BOARD OF COUNTY COMMISSIONERS
ORANGE COUNTY, FLORIDA

ADDENDUM NO. 3 / IFB NO. Y18-758-TA

SOUTH SERVICE AREA/EAST SERVICE AREA (SSA/ESA) 36-INCH POTABLE
WATER MAIN, 24-INCH RECLAIMED WATER MAIN AND J. LAWSON BLVD
POTABLE WATER RE-PUMP FACILITY

SCALE: AS SHOWN
DRAWING NO.:
E-10
SHEET: 167 OF 292

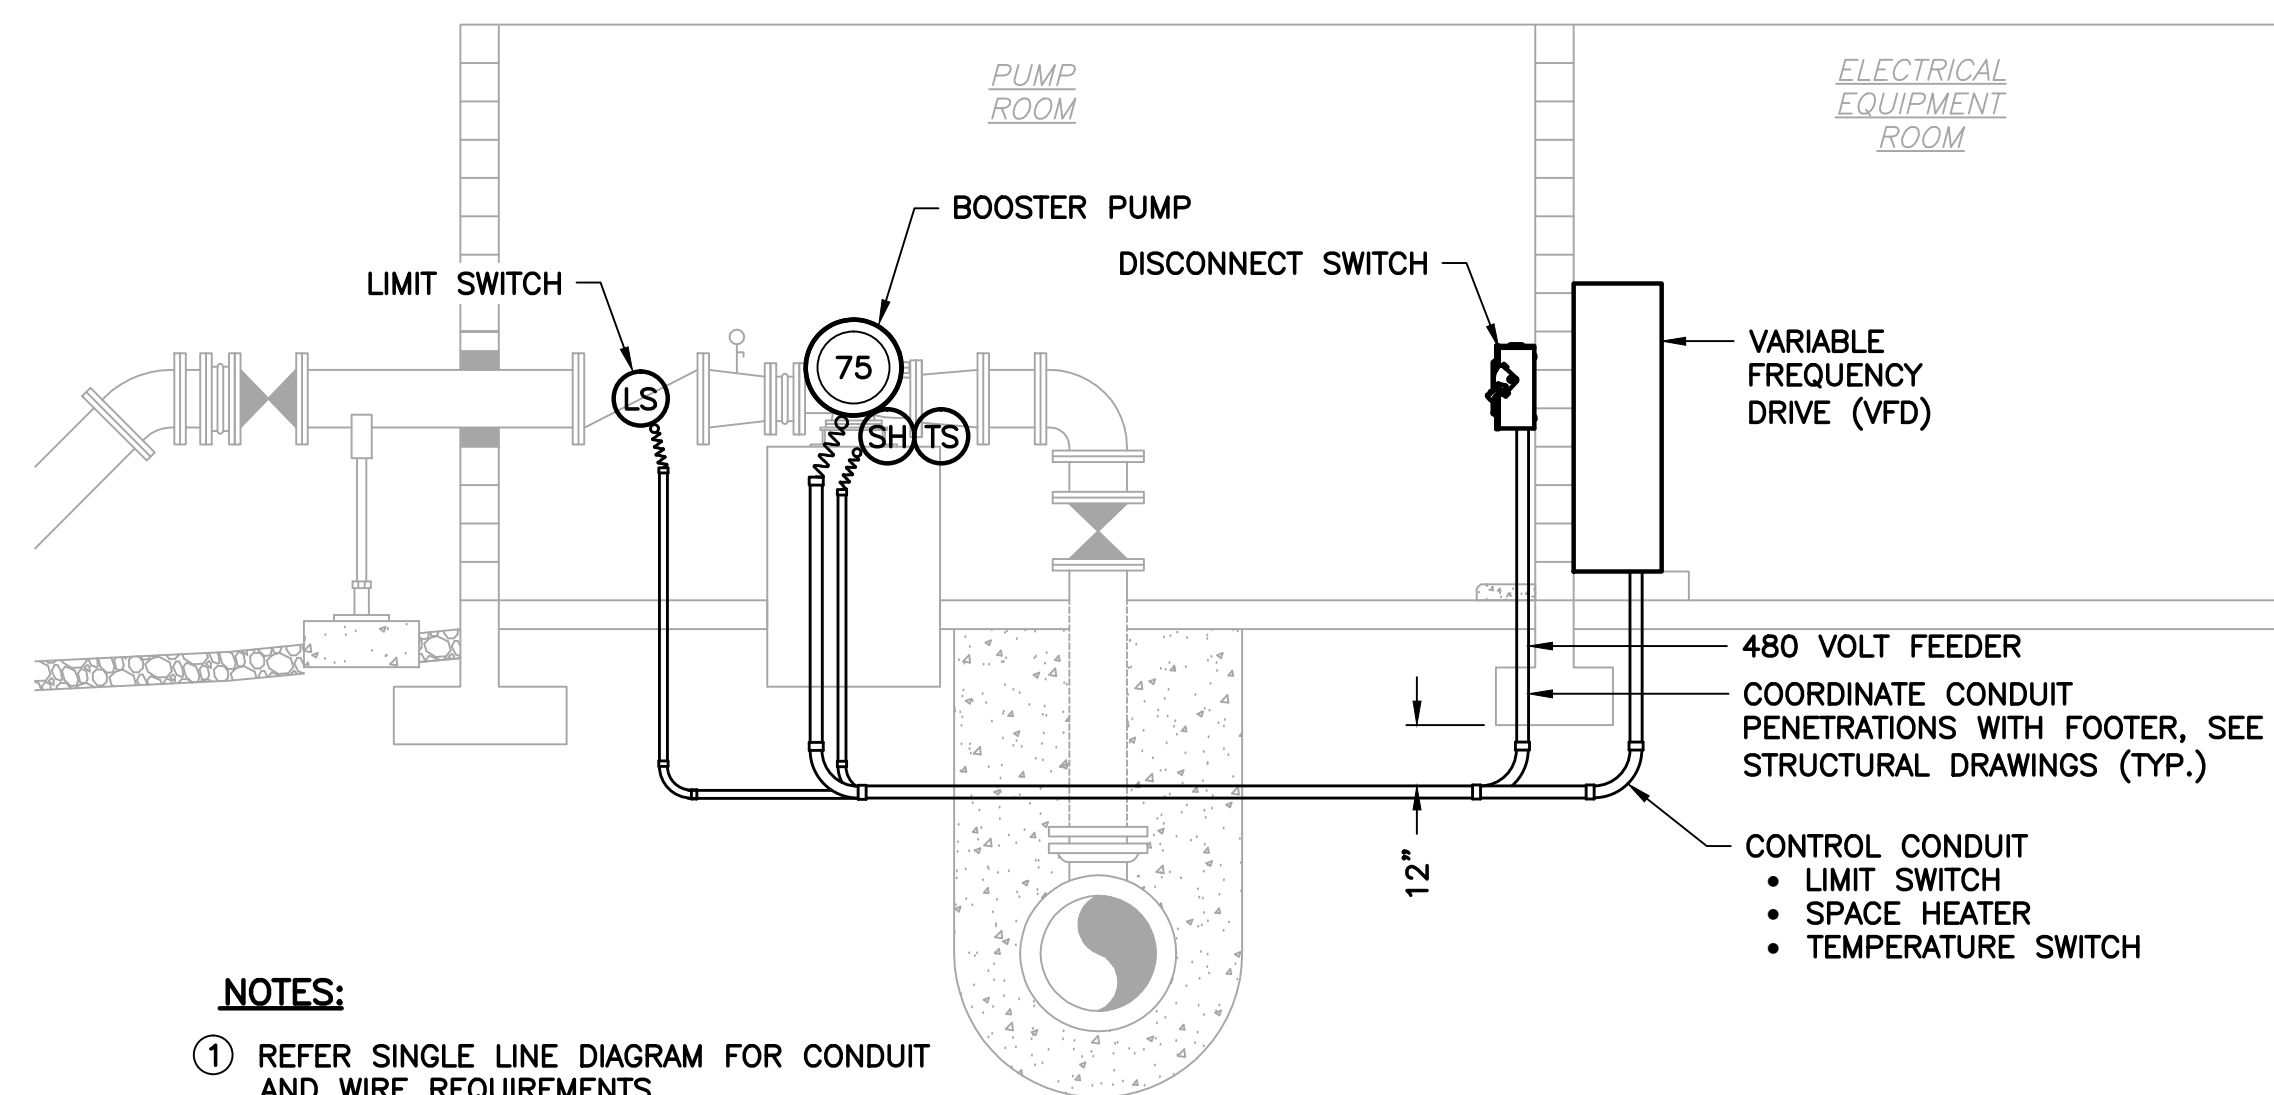
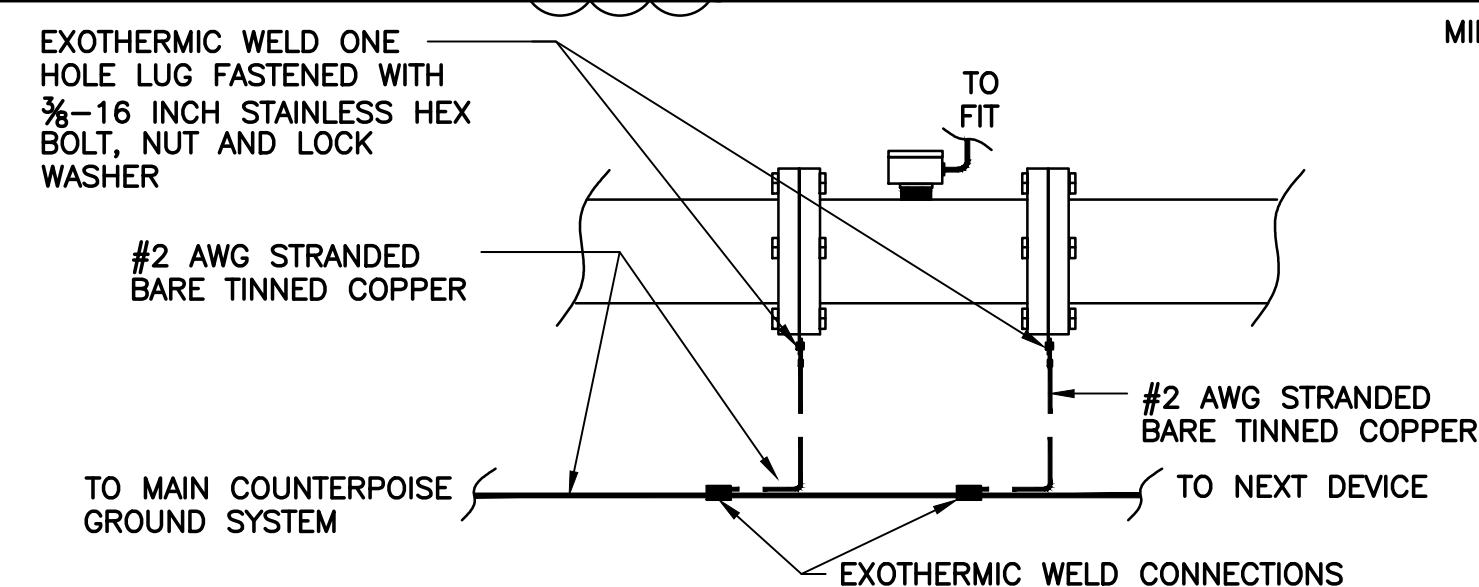
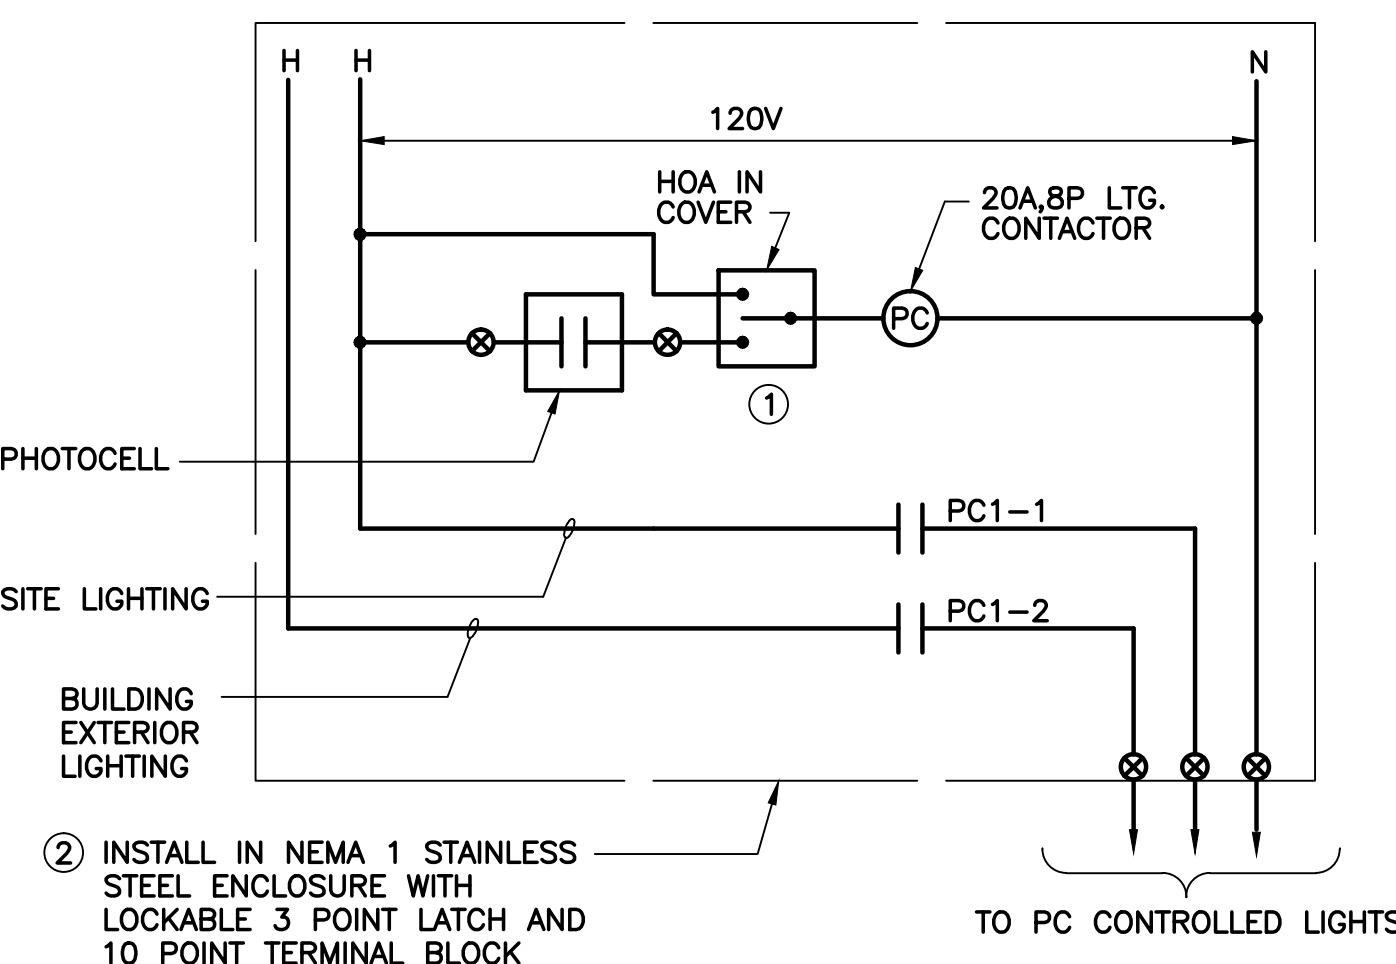
DRAWING A1.0, E-07, and E-10

Amend: Delete drawings A1.0, E-07, and E-10 and replace with the revised drawings A1.0, E-07, and E-10. The revised drawings show the overhead door 103B on A1.0 being electrically operated and power running to the overhead door.

SCALE: AS SHOWN
 DRAWING NO.:
I-02
 SHEET: 176 OF 292

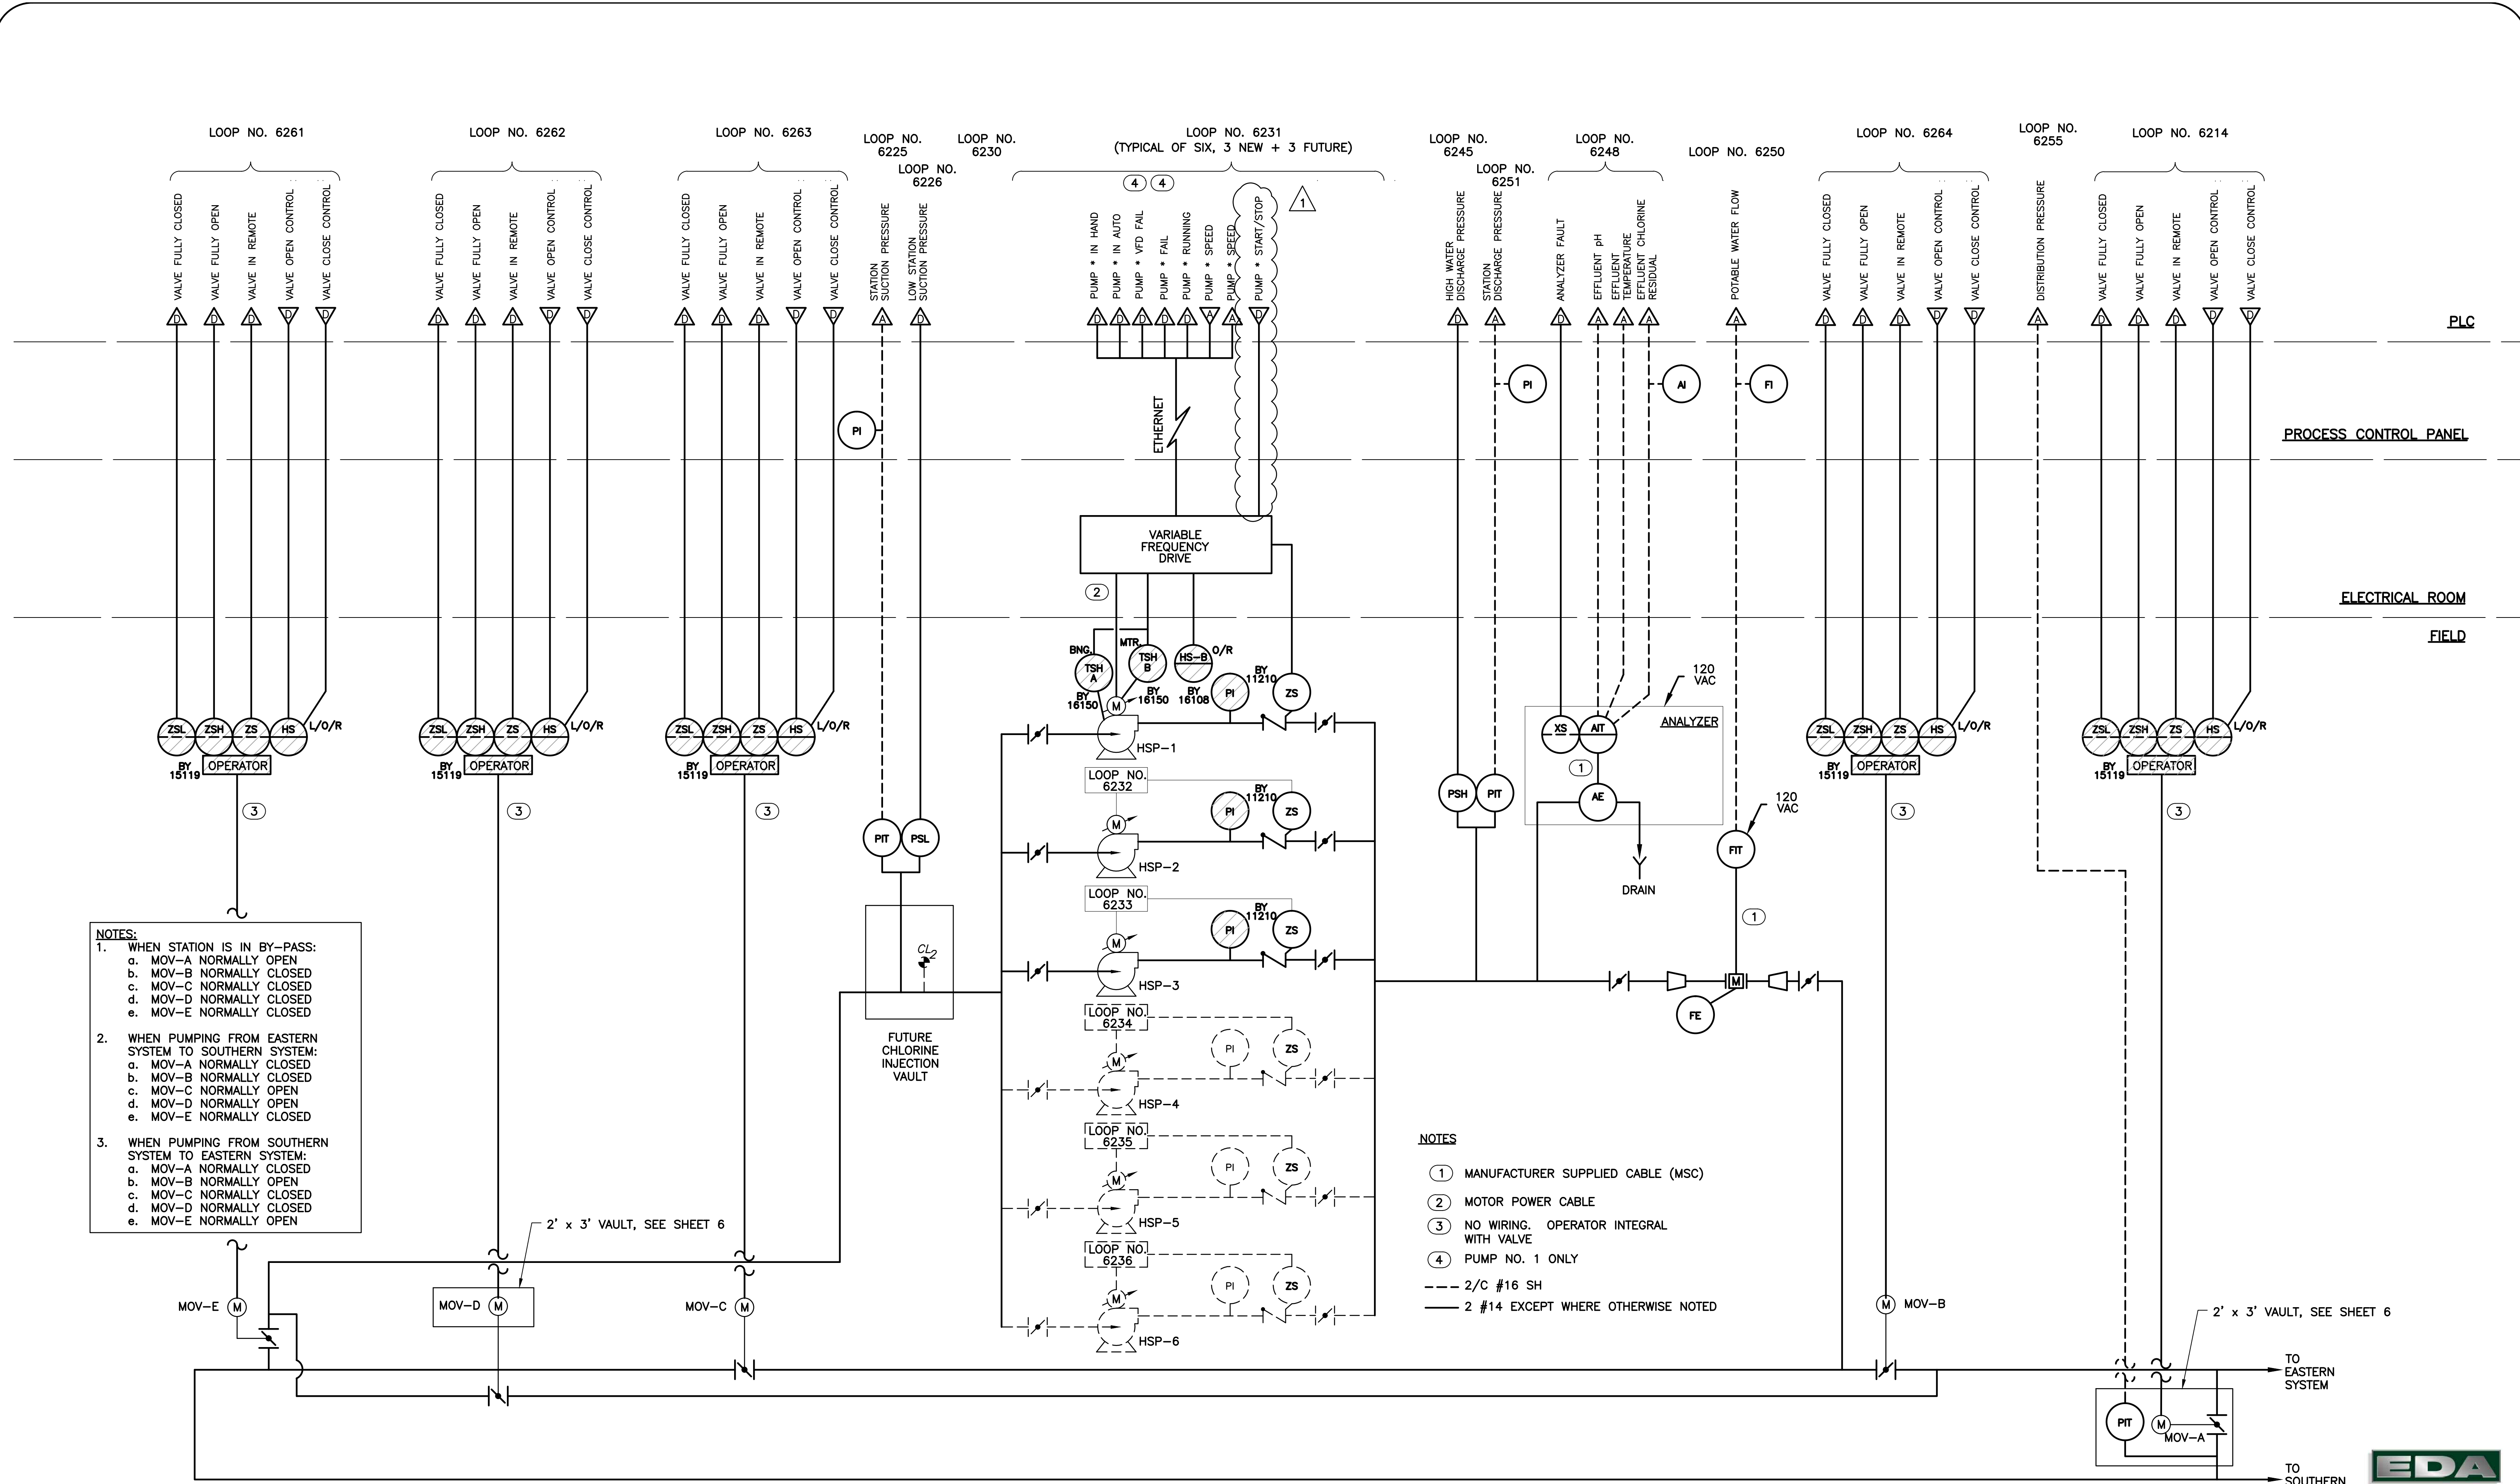
9. Q: I-02 show the VFD I/O being transmitted via Ethernet whereas E-05 shows a hardwire connection; please clarify which is to be used.

DRAWINGS E-04, E-05, and I-02

A: VFD I/O to be transmitted via Ethernet except the Pump start/stop (control) which is to be hardwired. See revised drawings E-04, E-05, and I-02.

Amend: Delete drawings E-04, E-05, and I-02 and replace with the revised Drawings E-04, E-05, and I-02. The revised drawings show the VFD I/O to be transmitted via Ethernet and the Pump start/stop (control) being hardwired.
